2010 Annual Revision Cycle

National Electrical Code® Committee Report on Proposals

This Report contains the proposed amendments for the 2011 National Electrical Code® for public review and comment prior to October 23, 2009, and for consideration at the NFPA June 2010 Association Technical Meeting

Figure 90.2

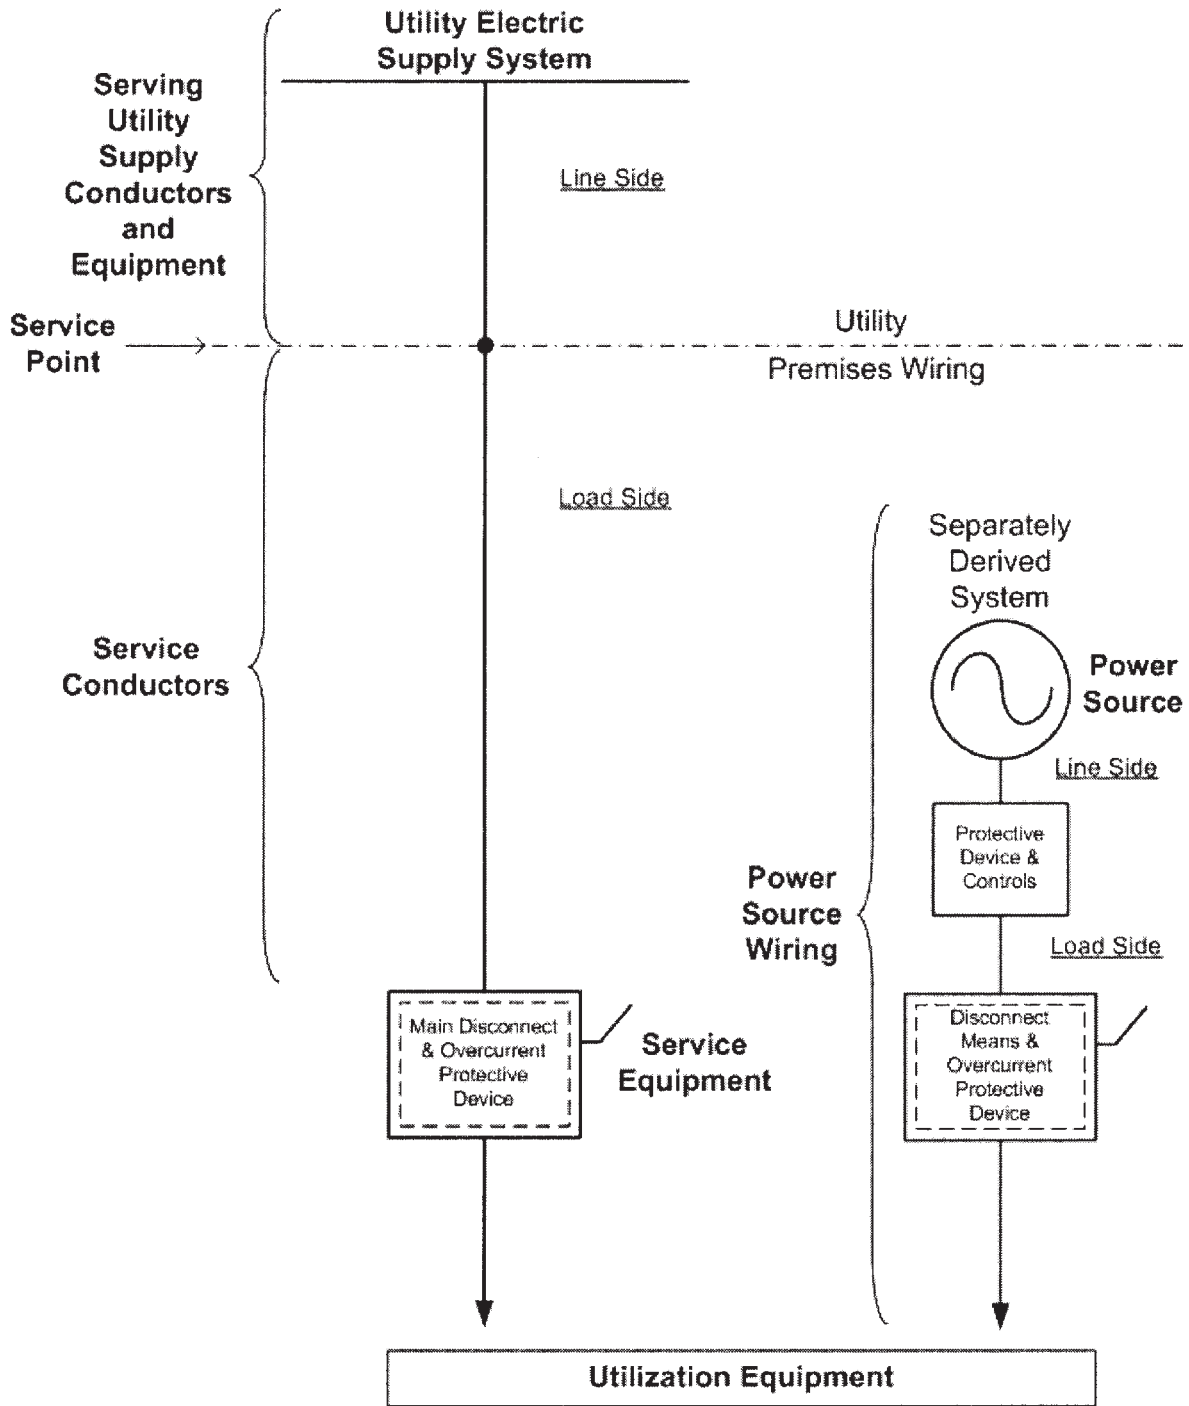
Specifically, the rationale for this change is to add an illustrative figure to 90.2 to provide visual clarity where the NEC applies to premises wiring meeting the supply facilities under exclusive control of utilities at the service point and to separately derived systems that are not connected to a service point. The location of the service point and utility equipment to provide electric service to premises wiring is dependent upon the governmental or regulated serving utility's local requirements or those of a private utility under governmental oversight or conditions of service (e.g. tariffs with service applications).

Panel Statement: The proposal does not enhance clarity or usability. Proposed Figure 90.2 does not apply to all installations and does not clarify exclusive control.

Figure 90.2

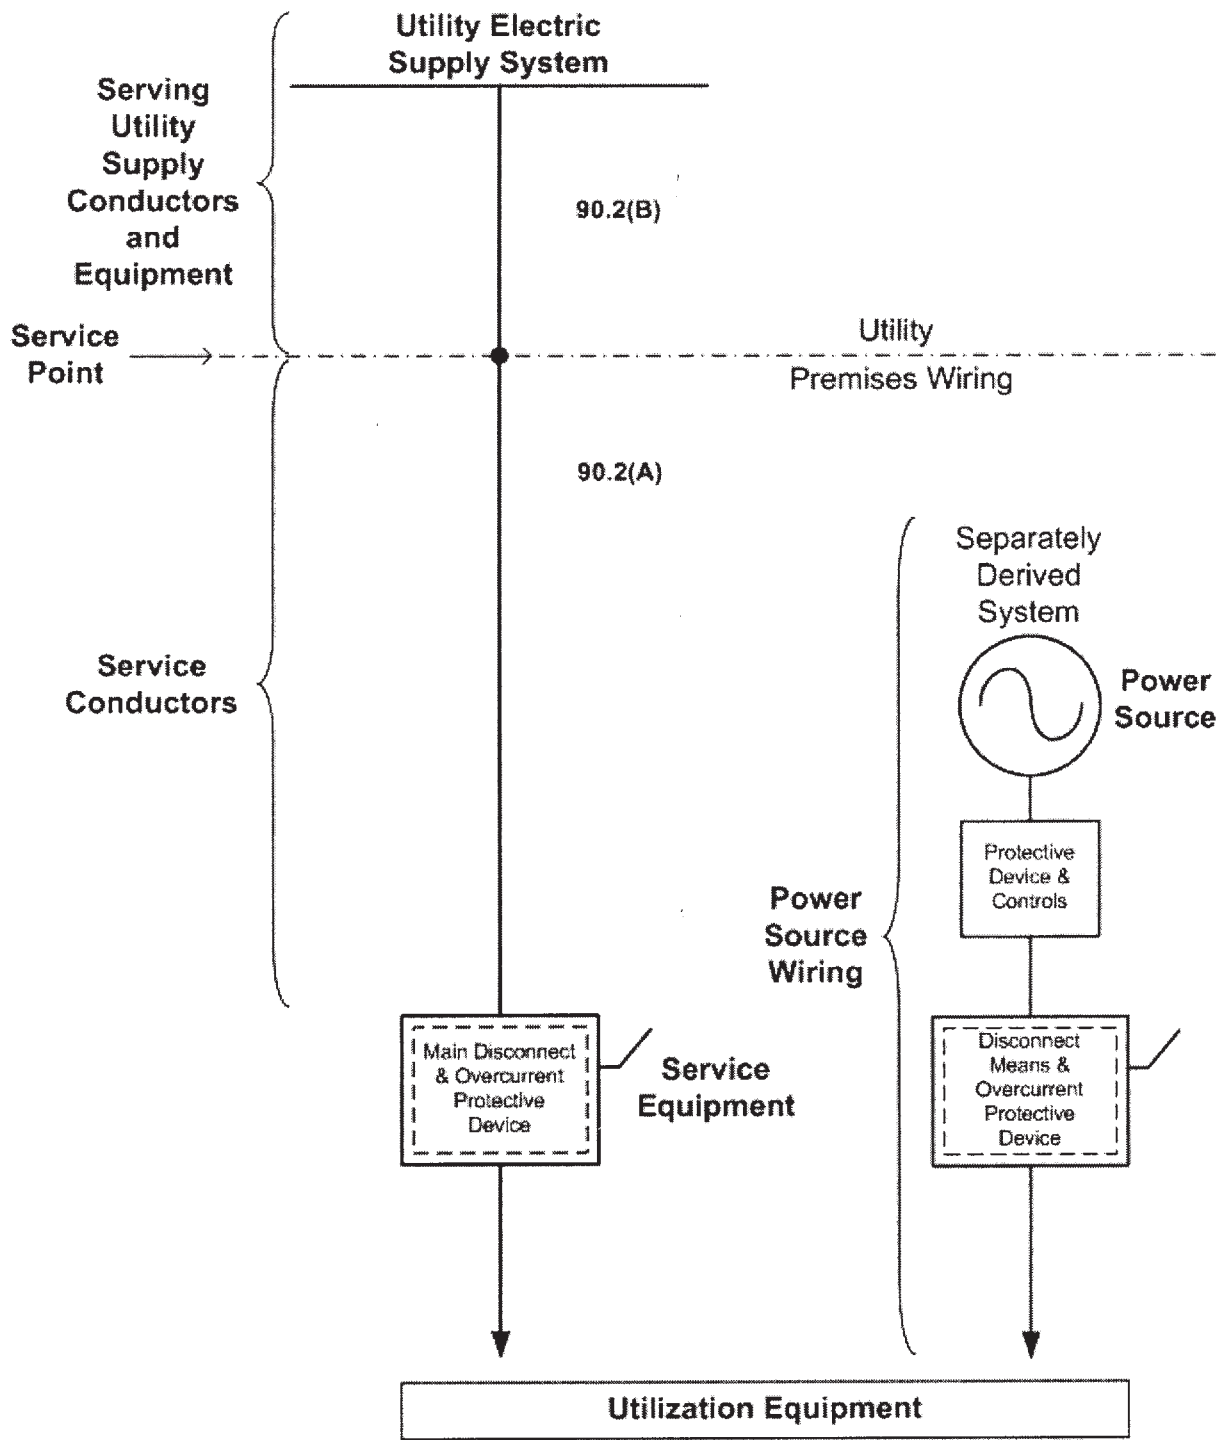
ANTHONY, M.: The addition of the phrase "premises wiring" does add clarity, in our view.

Exhibit 110.12 The 30 in. wide front working space, which is not required to be directly centered on the electrical equipment if space is sufficient for safe operation and maintenance of such equipment.

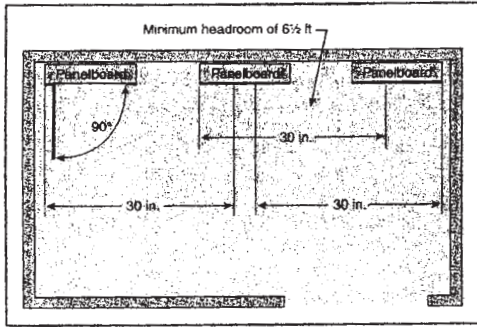
Substantiation: 1. The rules regarding space around equipment is one of the most consulted and most difficult parts of the NEC. This illustration, scanned from the 2005 NEC Handbook, will help NEC users.

Exhibit 110.14 Basic Rule, first paragraph. At least one entrance is required to provide access to the working space around electrical equipment [110.26(C)(1)]. The lower installation would not be acceptable for a switchboard rated 1200 amperes or more.

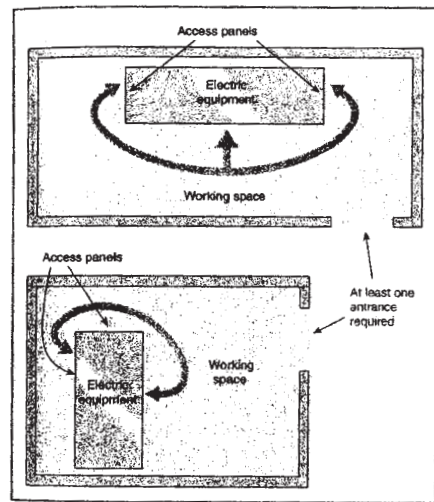
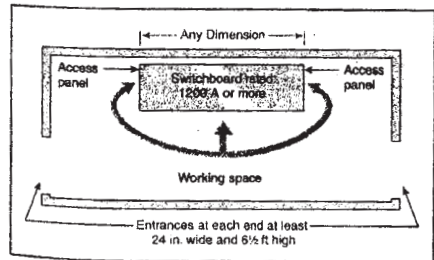
most consulted and most difficult parts of the NEC. This illustration, scanned from the 2005 NEC Handbook, will help NEC users.

Exhibit 110.19 The two distinct indoor installation spaces required by 110.26(A) and 110.26(F): the working space and the dedicated electrical space.

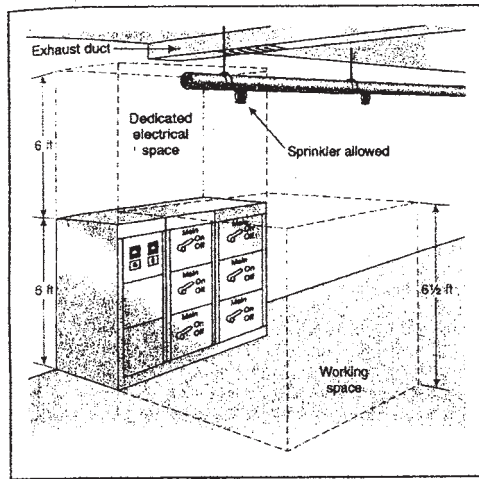
Substantiation: 1. The rules regarding space around equipment are one of the most consulted and most difficult parts of the NEC. This illustration, scanned from the 2005 NEC Handbook, will help NEC users.

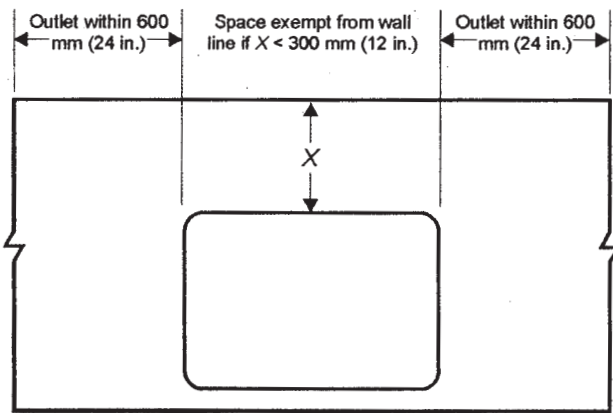
Replace the upper drawing in Figure 210.52(C)(1) with the following proposed revision:

Revise the text in Figure 210.52(C)(1) to read, “Figure 210.52(C)(1) Determination of Area Behind a Range, or Counter-Mounted Cooking Unit, or Sink.”

The upper drawing in Figure 210.52(C) needs to be revised as shown as most commonly, counter-mounted cooking units, rangetops and sinks do not extend from the face of kitchen counters. And, that is not the issue being addressed. This section addresses whether the appliance or sinks create a separation of the countertop for the purpose of determining the appropriate placement of receptacle outlets.

Figure 210.52(C)(1) Determination of Area Behind a Range, or Counter-Mounted Cooking Unit or Sink

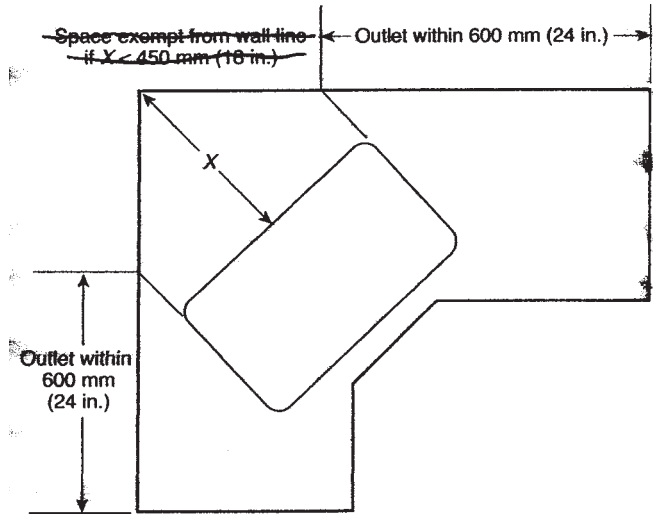
Recommendation: Revise Figure 210.52(C)(1) as follows:

Substantiation: Both of the illustrations in Figure 210.52(C)(1) are commonly complemented by windows at least as wide as the cooking unit or sink leaving no provisions for the installation of an ac receptacle. The bottom illustration typically consists of 2 windows on either side of the corner with solid framing between them. Note that 406.4(E) prohibits mounting receptacles face-up. The code is impractical in most applications.

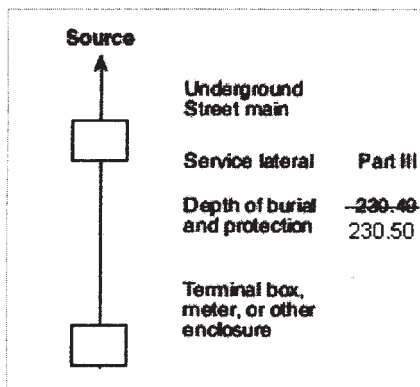
Source Serving Utility
 The word "Source" near the top of Figure 230.1 Services is incorrect, it should be deleted and replaced with the words "Serving Utility".
Substantiation: The use of the word "Source" is not defined, whereas the "serving utility" is contained in the definition of "Service" in Article 100. By definition, the "Service" is supplied only from the "Serving Utility".
 This correction will help to eliminate confusion and misapplication of Article 230 to Article 215. This correction will also help to remove confusion of when to apply 250.24 or 250.30, especially with the installation of distributed generation systems.

Submitter: Thomas A. Domitrovich, Eaton Corp.
Recommendation: Replace "230.49" with "230.50" in Figure 230.1.

Substantiation: This figure references section 230.49 which previously, as per the 2005 NEC, was entitled "Protection Against Physical Damage - Underground". This section has been moved into section 230.50, "Protection Against Physical Damage". Figure 230.1 should accurately reference the current section.

Replace "230.49" with "230.32" in Figure 230.1.
Panel Statement: The correct reference is 230.32 under part III of Article 230.
Number Eligible to Vote: 10
Ballot Results: Affirmative: 10

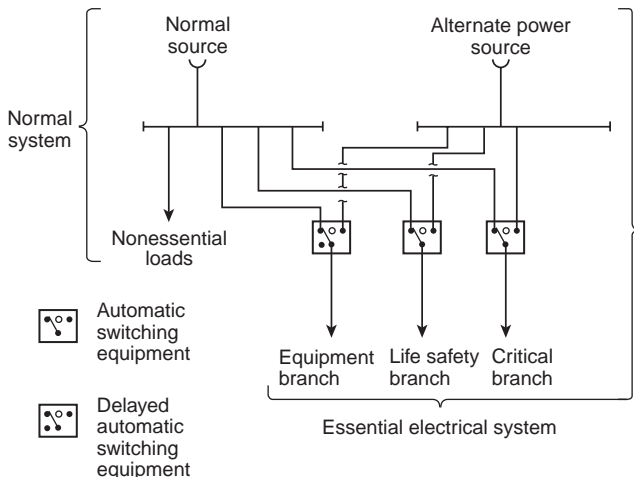
SAMPSON, M.: The panel should look closely at the lack argument for reconfiguring the essential system by eliminating the emergency system tier. The emergency system of a hospital is for life safety - a branch for those exiting the building and one for those who cannot. Removing the word “emergency” from Article 517 to escape the requirements of Article 700 is clearly cost driven and not in the best interest of the building occupants.

WHITE, A.: The code making cycle for NFPA 99 is not yet complete. Any action taken before this standard is issued by Standards Council is premature.

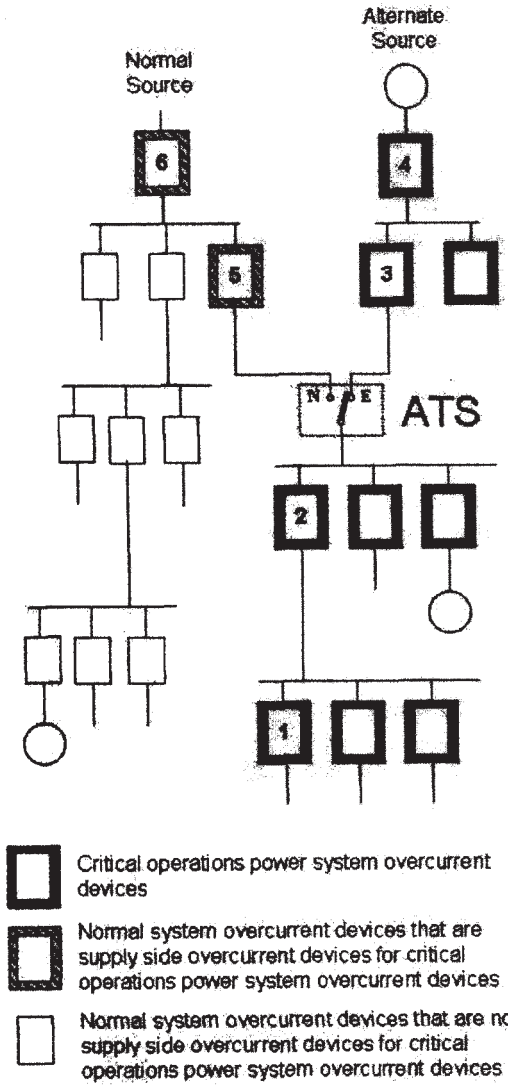
Substantiation: This proposal is an attempt to clarify the confusion concerning selective coordination requirements.
